To: INCITS Technical Committee T10  
From: Kevin Butt  
Date: Wednesday, October 08, 2008 1:23 pm  
Document: T10/08-407r1 — iADT: ADT Port State Machine

Figure 1 — ADT Port Connection State Diagram

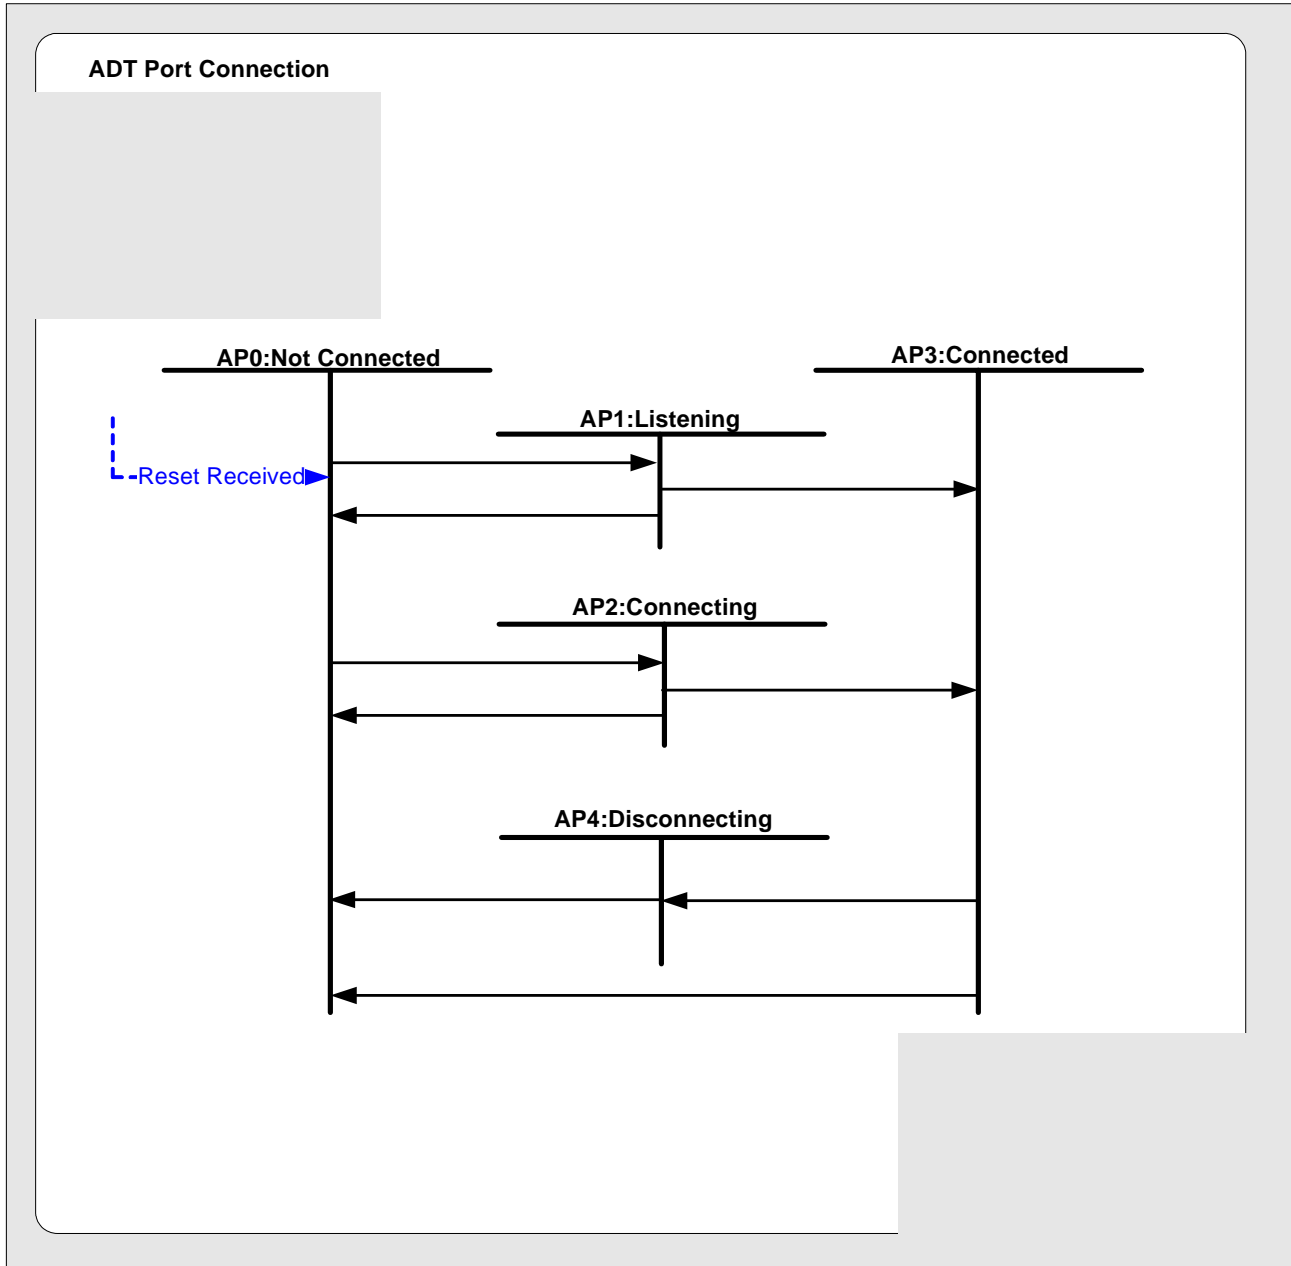
- 08-407r0 (07 October 2008) Initial revision
- 08-407r1 (08 October 2008) Incorporated comments from ADI phone conference and added transition from AP1:Listening to AP0:Not Connected. Added notes to point out where items may need to be added.

Figure 1 shows the ADT Port Connection state machine. The following subclauses describe the transitions and the actions taken in each state.
